# Multi-Pollutant Emissions Standards for Model Years 2027 and Later Light-Duty and Medium-Duty Vehicles

## Response to Comments

Assessment and Standards Division  
Office of Transportation and Air Quality  
U.S. Environmental Protection Agency

SEE ORIGINAL COMMENT FOR Figure 36: Fuely.com data for 2019 Chevrolet Volt.

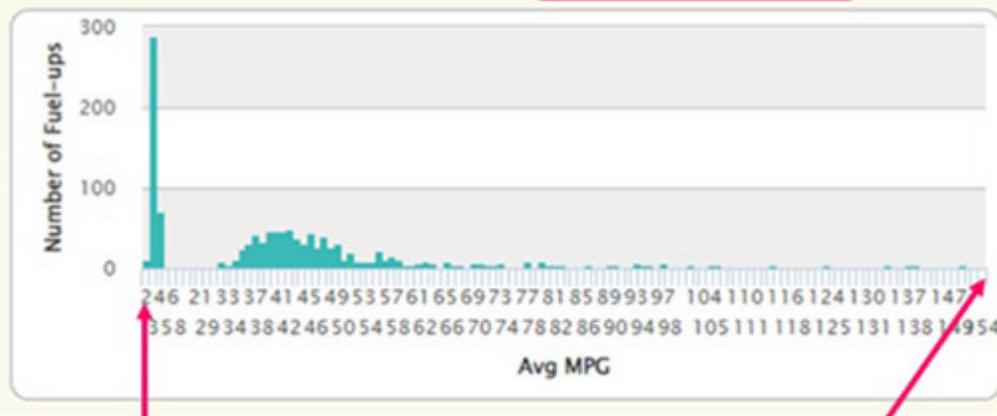
The refueling events for PHEVs having an accurately high charging frequency and utility factor have been excluded as outliers by the Fuely application because their fuel economy is deemed too high. For example, a regularly charged Chevrolet Volt can attain 200+ MPG which can be filtered from the distribution of re-fuel events because the value lies beyond Fuely’s 3-sigma screening limit that is applied to fleet average MPG (see Figure 36 below). These omissions further mischaracterize PHEV real-world fleet performance. [EPA-HQ-OAR-2022-0829-0701, pp. 124-127]

[See original for graph titled “Figure 2. Plug in Hybrid Electric Vehicle Utility Factors from Bureau of Automotive Repair Data.”] [EPA-HQ-OAR-2022-0829-0780, pp. 20-22]

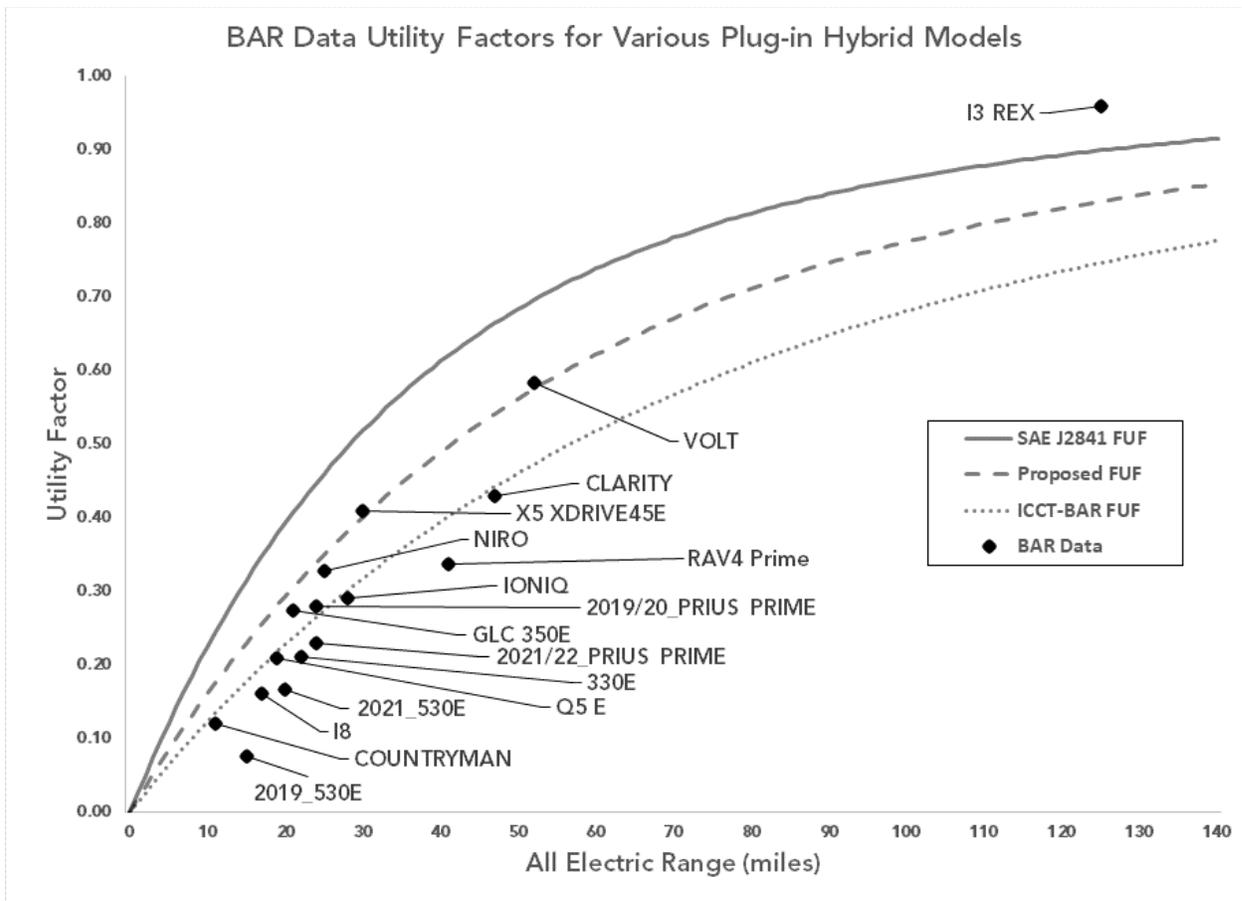
Figure 2 and Table 1 present CARB’s results. As shown in Figure 2, most recent PHEV models fall below both the SAE J2841 22 curve and U.S. EPA’s proposed FUF curve. Rather, the ICCT-BAR FUF curve that U.S. EPA’s presents—but is not proposing to use—appears to be better correlated with actual real-world electric operation in these cases, and CARB’s analysis reaffirms ICCT’s original analysis. The notable exceptions are two vehicle models with unique architectures and higher all-electric ranges: the 2019 Chevrolet Volt (53-mile label range) and the 2019 BMW i3 REX (126-mile label range).<sup>23</sup> The 2019 Volt performed nearly identically to the U.S. EPA proposed FUF curve, and the i3 REX delivered more zero-emission miles than would be assigned under the SAE J2841 FUF. Notably, both of these models have been discontinued and used designs like a range-extender concept where the battery had to be depleted before the gasoline engine could be utilized. More recent models with similar all-electric capabilities like the Toyota RAV4 Prime and the Honda Clarity PHEV both averaged at or below even the lower ICCT-BAR FUF curve. [EPA-HQ-OAR-2022-0829-0780, pp. 20-22]

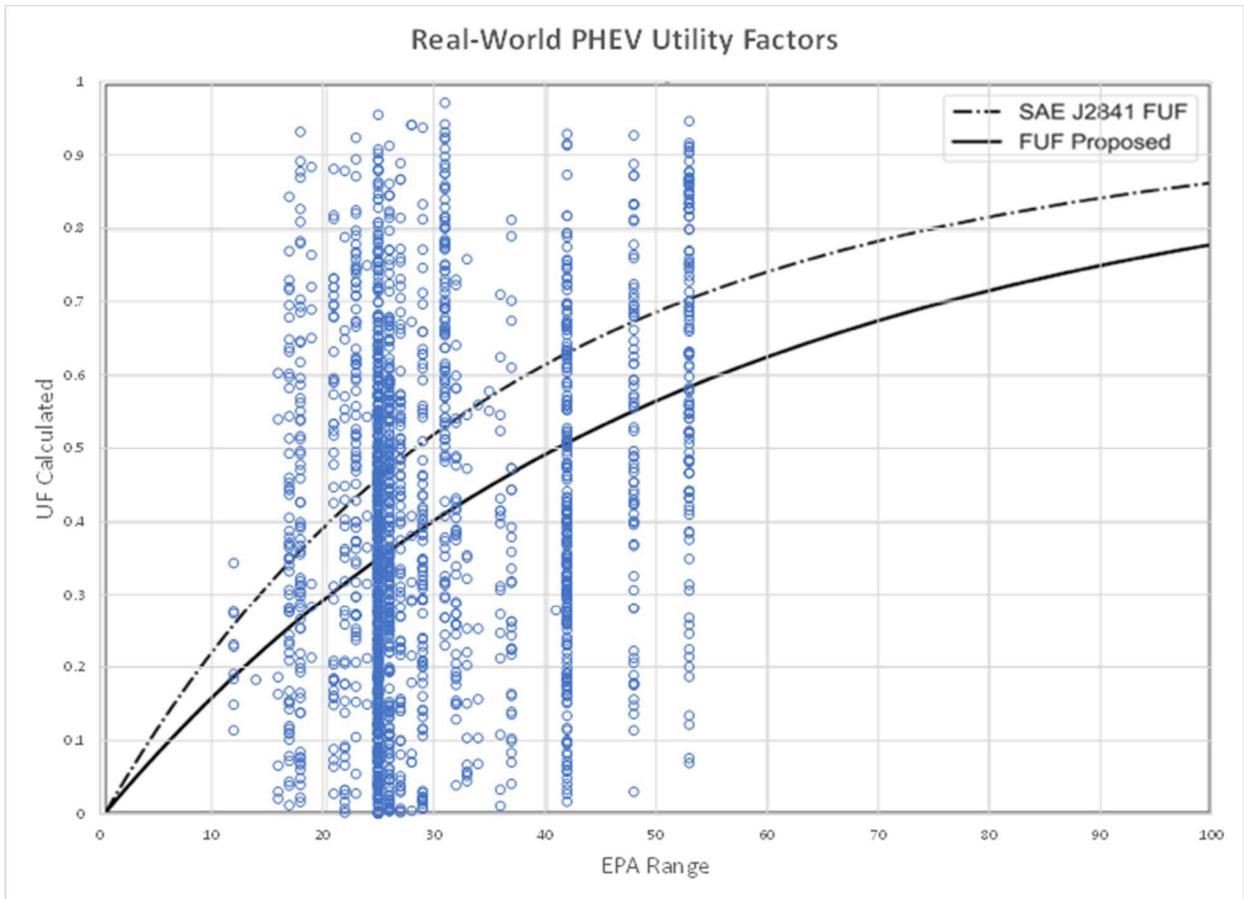
Figure 1 illustrates the set of individual vehicle-level UFs that are derived from an updated data pull from BAR. Of course, the data are extremely scattered and do not illustrate the validity of the UF curves for either the SAE J2841 FUF or the proposed FUF. When EPA or ICCT perform least-squares regression to derive a particular UF curve, they must calculate the confidence interval around the parameter estimates. When we perform that regression with vehicle models' pooled averages, we find that this dataset provides no evidence that the EPA FUF model is more representative than the SAEJ2841 model. [EPA-HQ-OAR-2022-0829-0646, pp. 14-18]

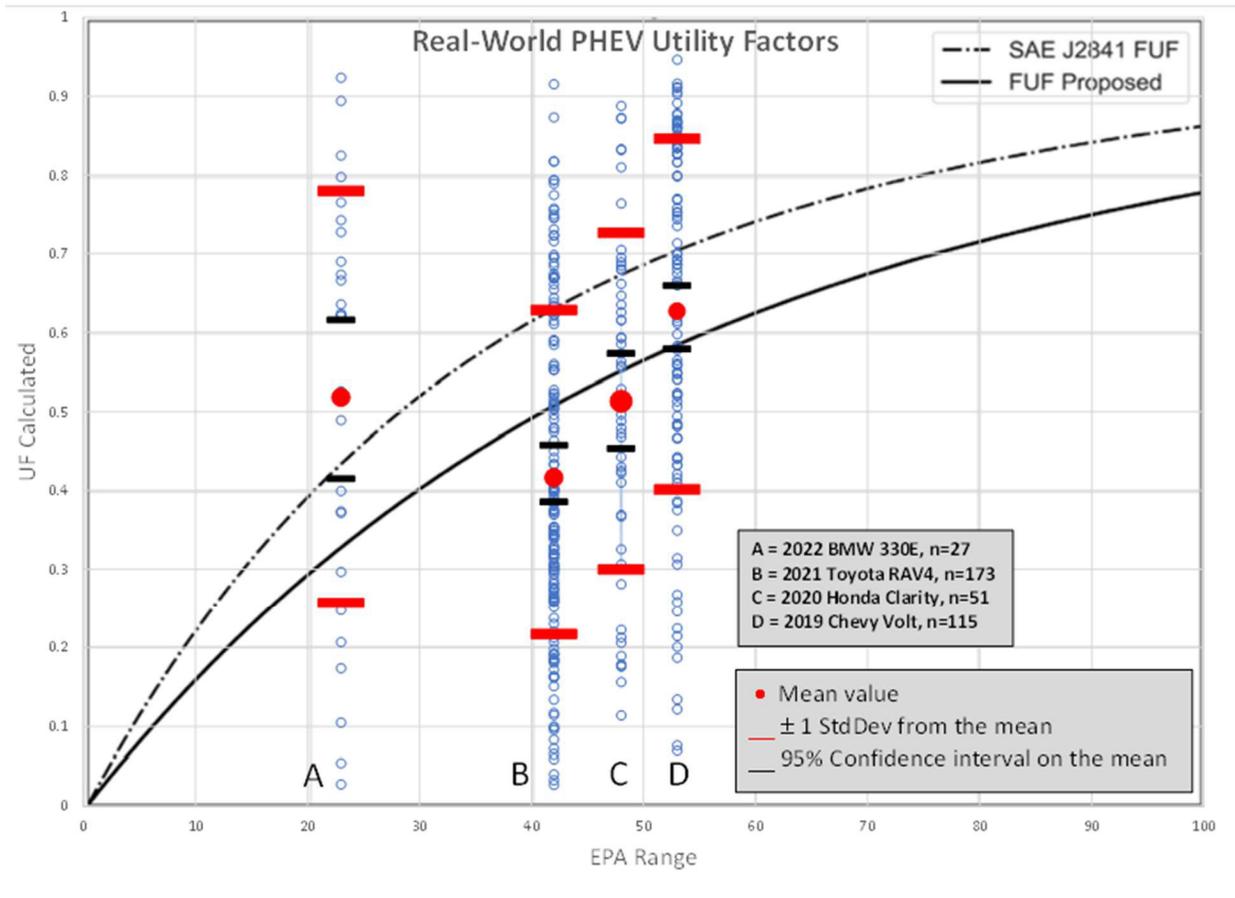
To illustrate this point more visually, Figure 2 provides additional statistical detail for some selected vehicle models. Figure 2 illustrates the wide dispersion of measured individual UFs and shows that the 95% confidence intervals on the mean value may or may not encompass any particular pre-derived response curve. [EPA-HQ-OAR-2022-0829-0646, pp. 14-18]

[See original for graphic on PHEV Miles Driven in Charge-Sustaining Mode (Using Gasoline) or Charge-Depleting Mode (Using Battery)] [EPA-HQ-OAR-2022-0829-0646, pp. 14-18]

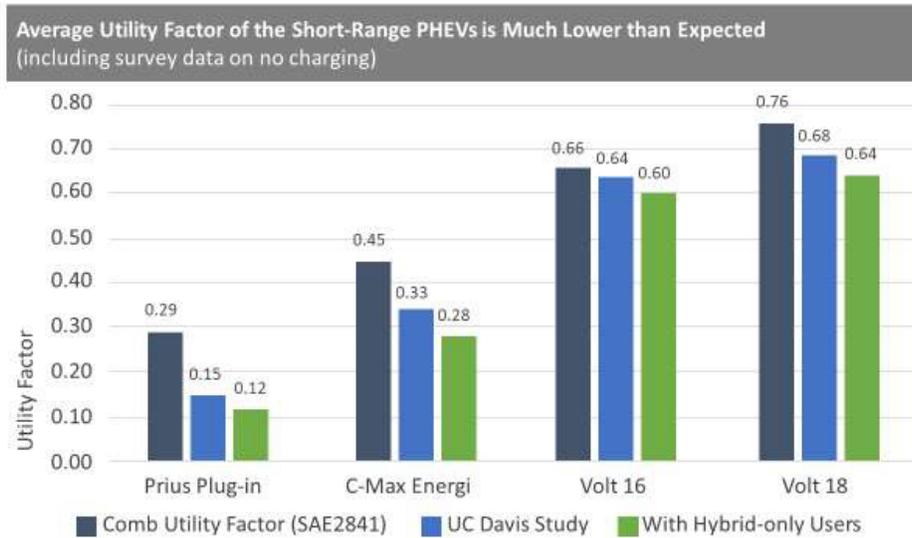
There are better data sets that support EPA using SAE J2741 for now. Regarding PHEVs not plugging in, there are many factors that impact plugging in and it is a complicated subject that needs more research.<sup>11</sup> This August 2020 paper from UC Davis is one of the best analyses and uses data loggers from actual drivers and shows that PHEVs with longer AERs do not have a substantial issue with not plugging in (e.g., about 3-5%).<sup>12</sup> See Table 1 below. Also, there are many factors that could see this decrease in the future. We make the case above that better data in the future will allow a new rulemaking on the FUF issue. [EPA-HQ-OAR-2022-0829-0646, pp. 14-18]

**Figure 1: Projected U.S. EV Battery Demand and Announced Battery Production Capacity (2022-2032)**

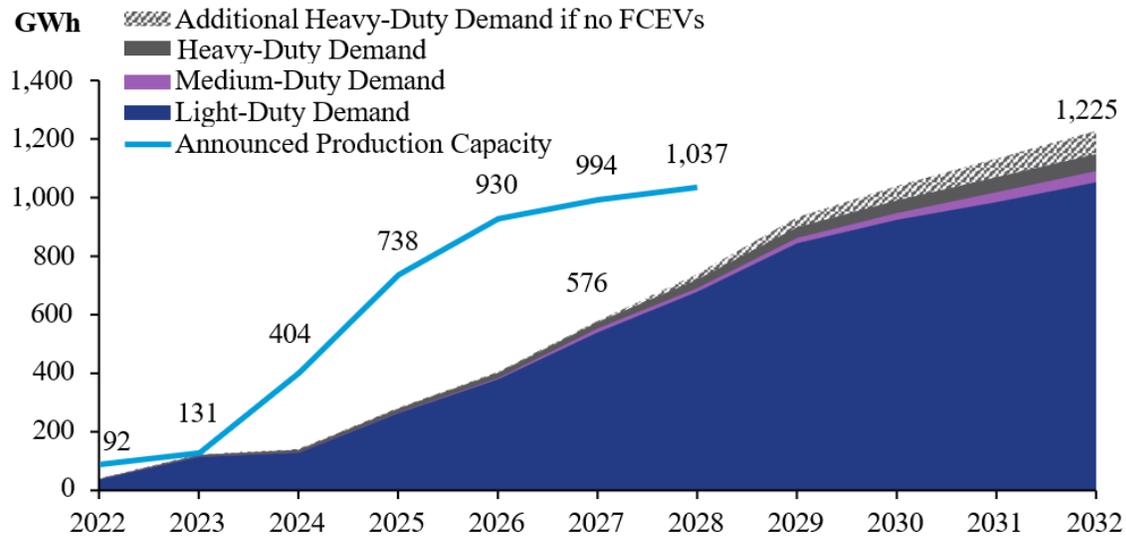
EDF used the EPA's projections for EV adoption and associated battery demand through 2030.<sup>ii</sup> Roughly 90% of the potential EV battery demand is from light-duty (passenger) vehicles. Potential demand for batteries in medium-duty vehicles (large pickup trucks and vans) and heavy-duty vehicles (delivery trucks, step vans, semi-trucks, buses, etc.) is much smaller.

Figure 1 shows EPA projected battery demand by segment:
